CCK-2642-23 ADDENDUM# 2 06/23/2022

University of Kentucky Purchasing Division 322 Peterson Service Building Lexington, KY 40506-0005 ADDENDUM NO. 2.00 6/22/2022

UK INDOOR TRACK FACILITY JRA Project No. 202258 UK Project 2584.0 University of Kentucky Lexington, Kentucky

Item No. 2.10

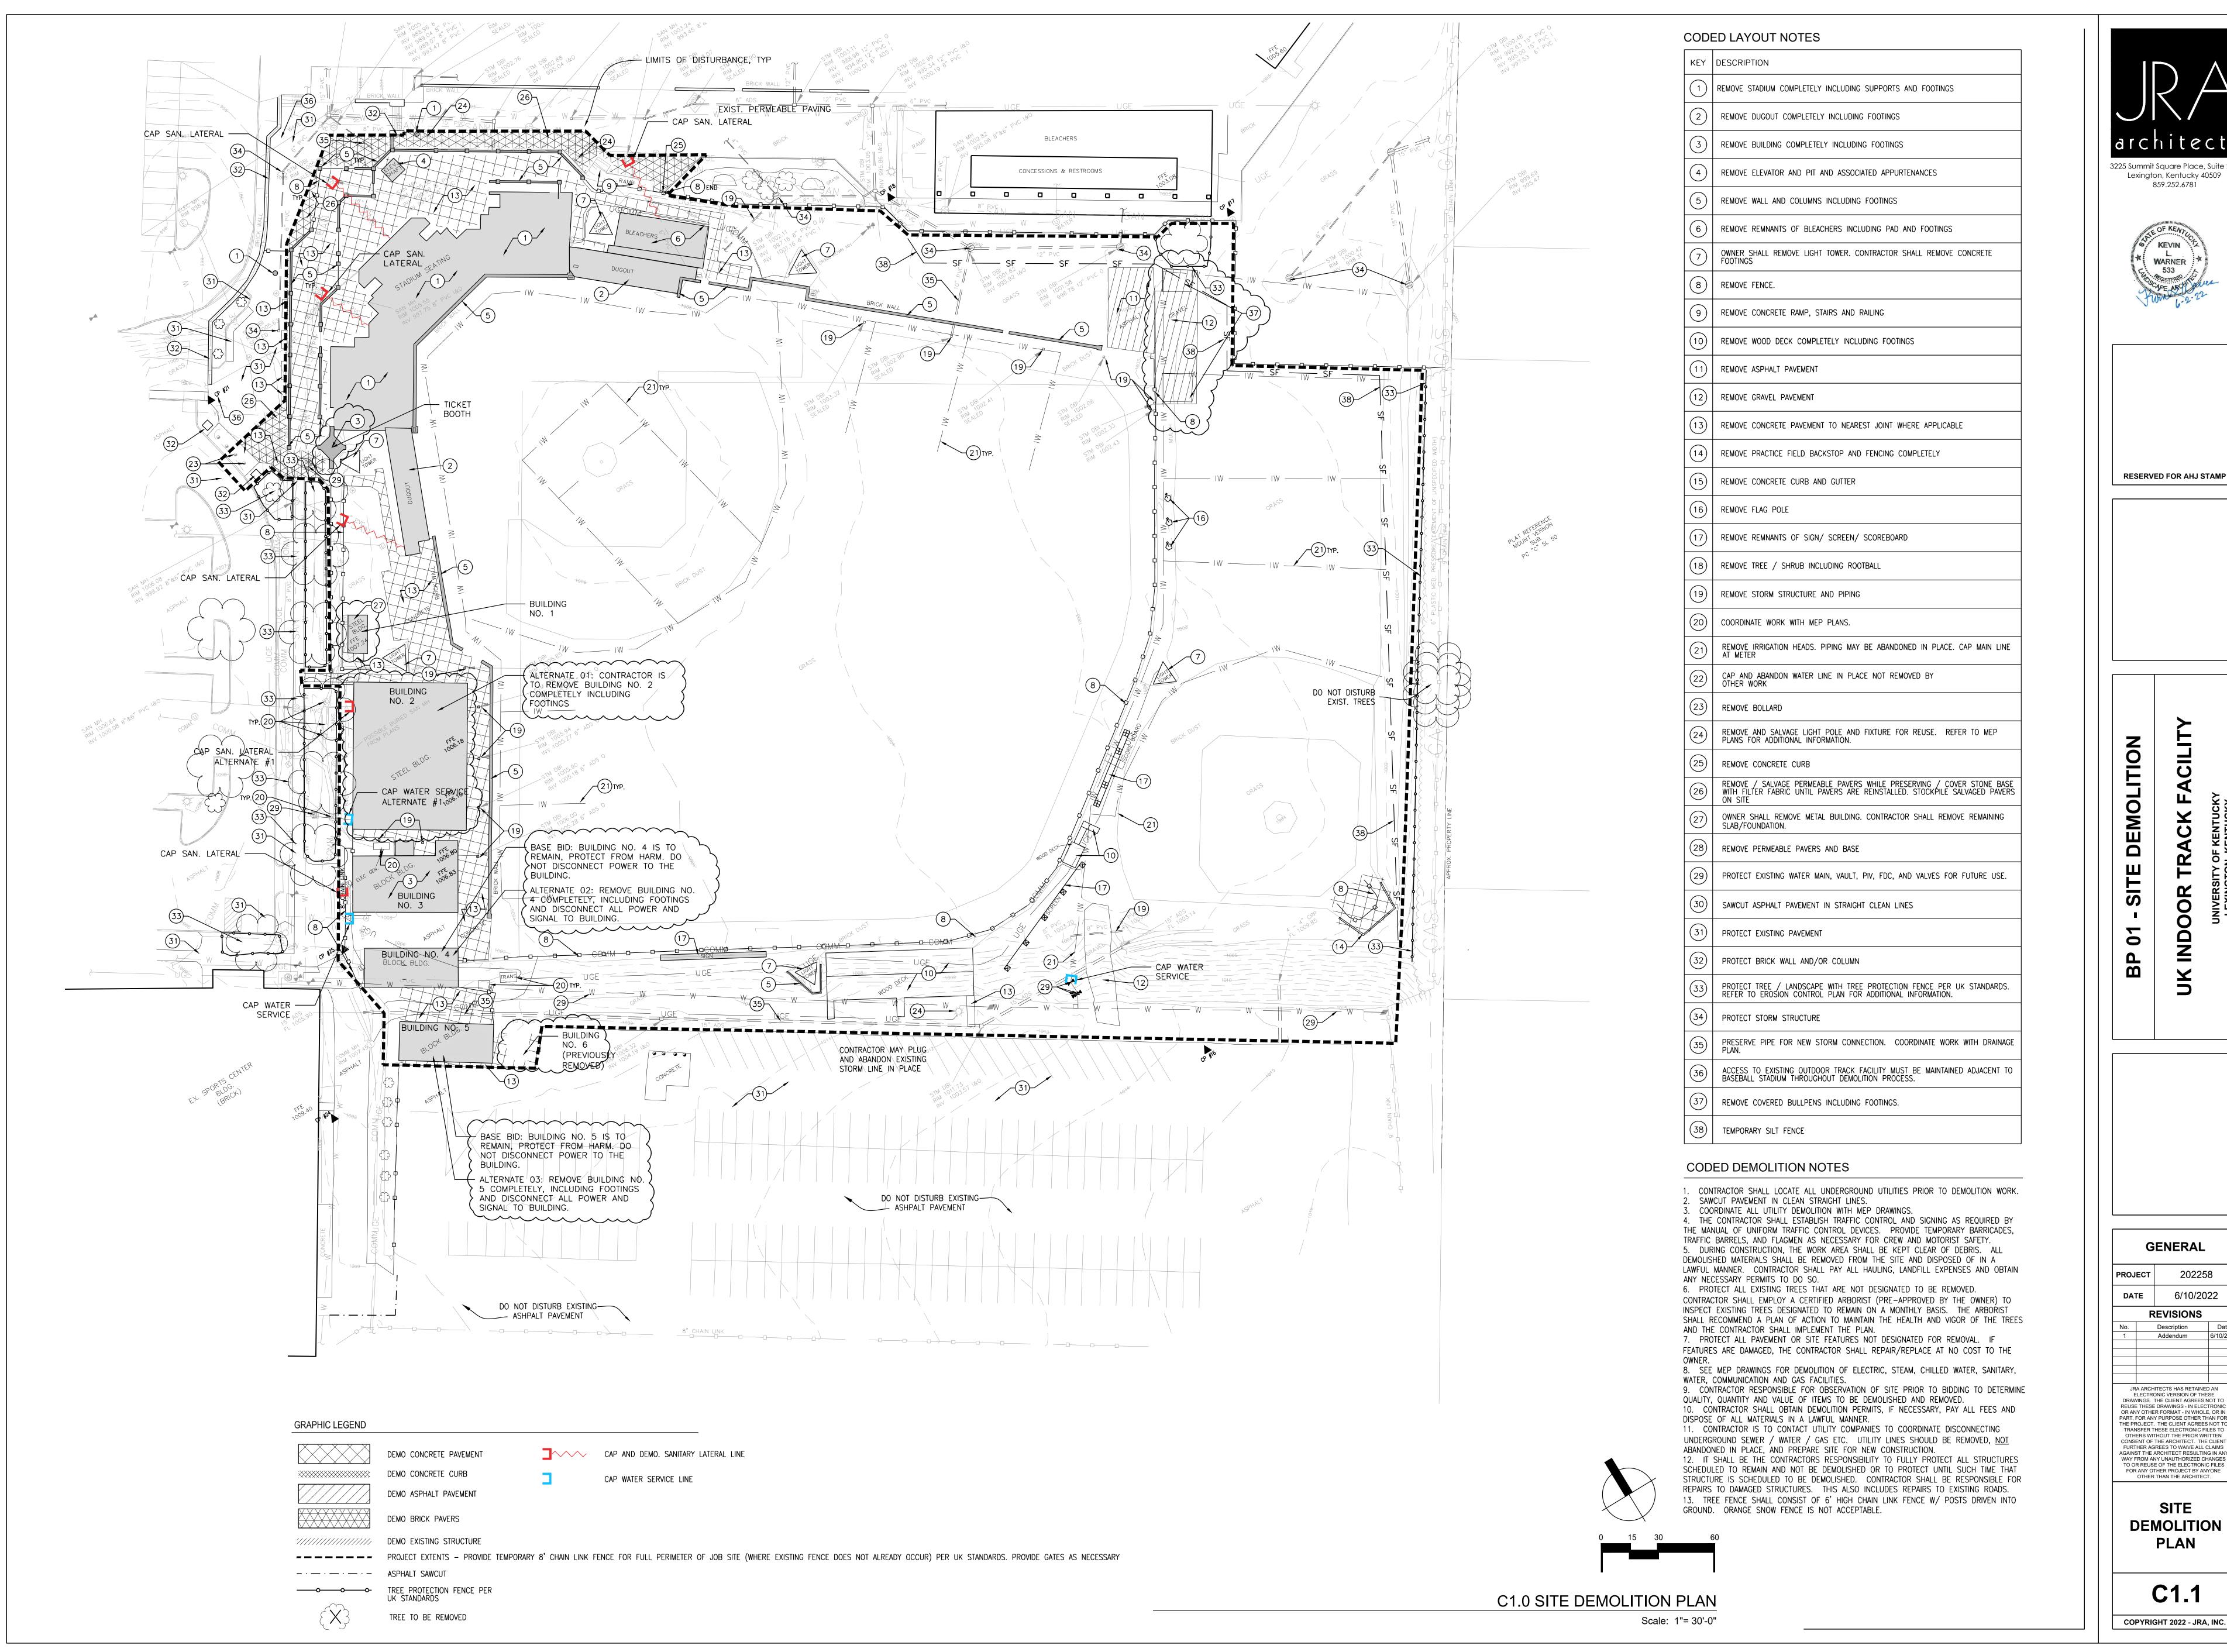
Pavers shall be salvaged with care to avoid chipping/cracking and stacked on pallets along the northern perimeter of the site (adjacent to the outdoor track stadium). Pavers shall be protected from damage throughout the duration of the demolition project.

> **DEMOLITION** PLAN

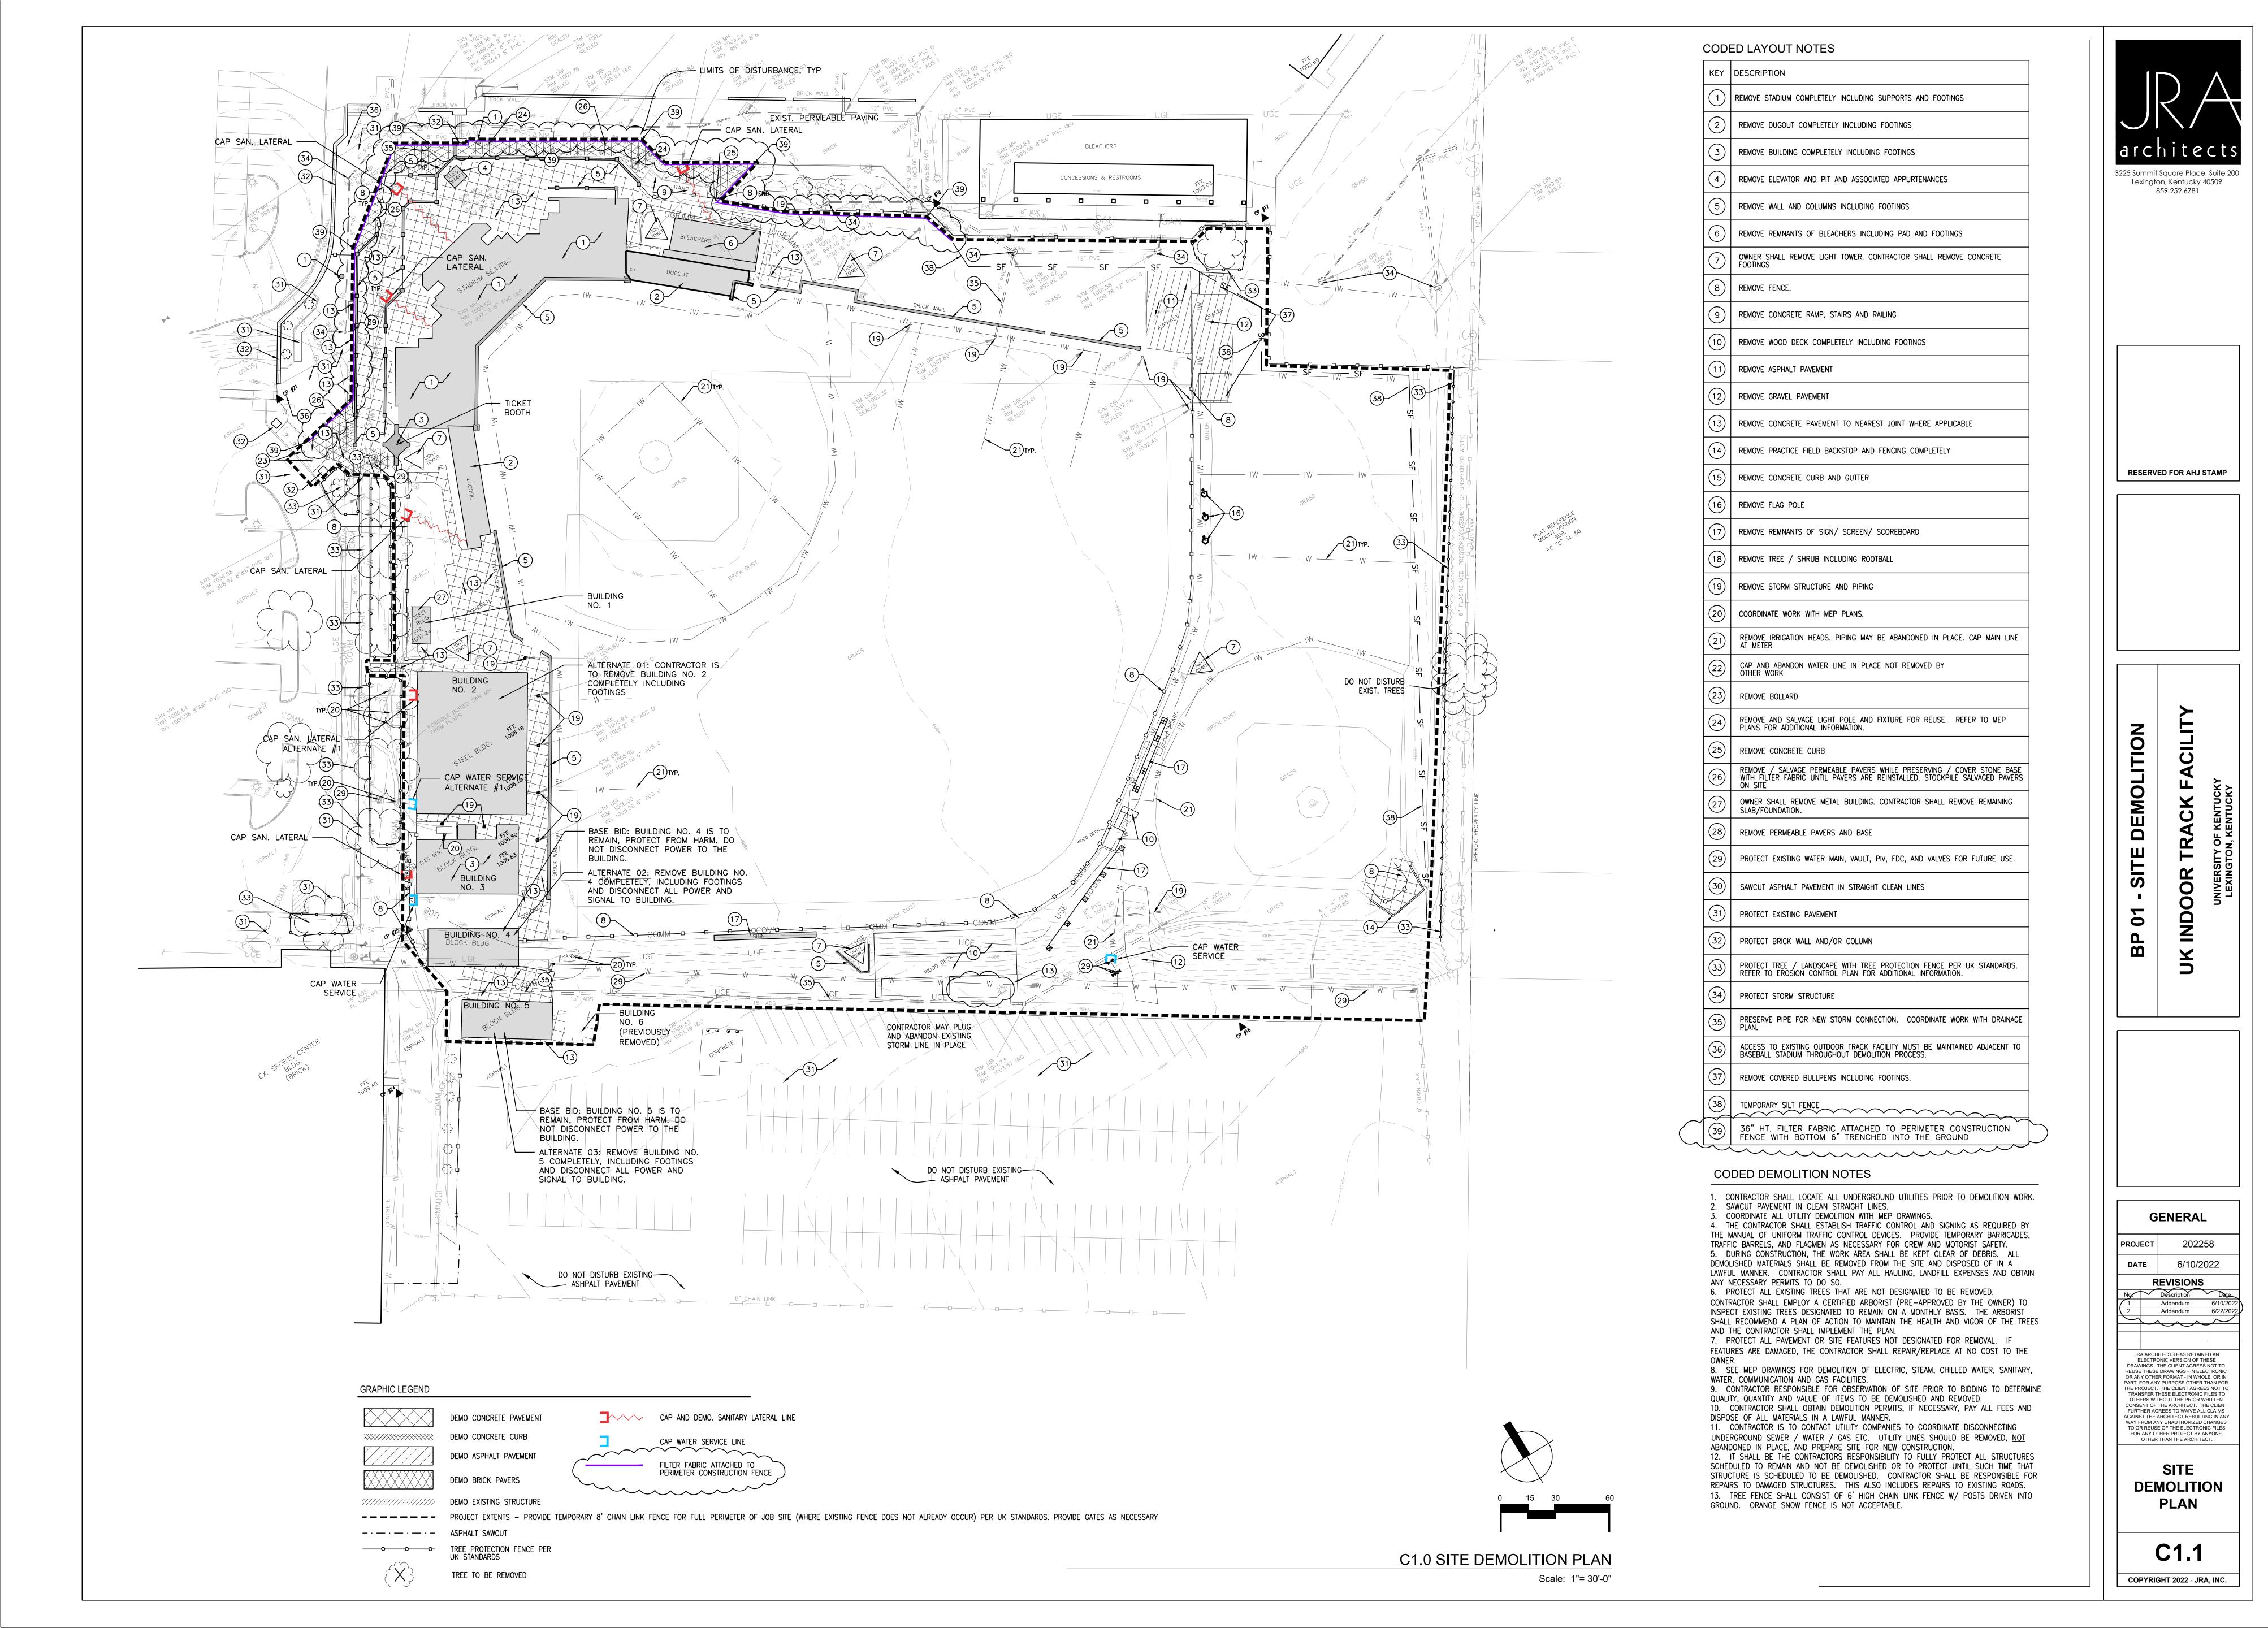
Refer to revised sheet C1.1 Site Demolition Plan and EU 100 that was absent in addendum 1. Per the addendum 1; the following designations have been added to identify the accessory buildings: "Ticket Booth", Building No. 1, Building No. 2, Building No. 3, Building No. 4, Building No. 5, and Building No. 6.

Refer to revised sheet C1.1 Site Demolition Plan that was absent in addendum 1. Per the addendum 1; add note 3 to the "Ticket Booth". Contractor is to remove "Ticket Booth" completely, including footings.

Refer to revised sheet C1.1 Site Demolition Plan that was absent in addendum 1. Per the addendum 1; add Alternate #1; Contractor is to remove Building No. 2 completely, including footings.

Refer to revised sheet C1.1 Site Demolition Plan that was absent in addendum 1. Per the addendum 1; for base bid, Building No. 4 is to remain, protect from harm. Do not disconnect power to the building. Add Alternate #2; Remove Building No. 4 completely, including footings, and disconnect all power and signal to building.

Refer to revised sheet C1.1 Site Demolition Plan that was absent in addendum 1. Per the addendum 1; For base bid, Building No. 5 is to remain, protect from harm. Do not disconnect power to the building. Add Alternate #3; Remove Building No. 5 completely, including footings, and disconnect all power and signal to building.

Refer to revised sheet C1.1 Site Demolition Plan that was absent in addendum 1. Per the addendum 1; the building labeled No. 6 on the plans was previously demolished and does not presently exist. Delete building 6 and the associated note number 3 from sheet C1.1 Site Demolition Plan.

Refer to revised sheet C1.1 Site Demolition Plan that was absent in addendum 1. Per the addendum 1; Contractor is to remove bullpens including footings.

Refer to revised sheet C1.1 Site Demolition Plan. 36" high filter fabric attached to perimeter construction fence with bottom 6" trenched into the ground added to North limits of disturbance.

A temporary construction fence, as depicted for the perimeter of the project on C1.1, shall be provided for the Demolition project and remain until substantial completion of the project. Construction manager at risk is to purchase temporary construction fence from demolition contractor after demolition is complete. The fence shall consist of 8' chain link fence with blue windscreen and posts driven into subgrade per UK standards.

Refer to revised sheet C1.1 Site Demolition Plan. Southern light pole to remain. Keynote 24 removed from southern pole.
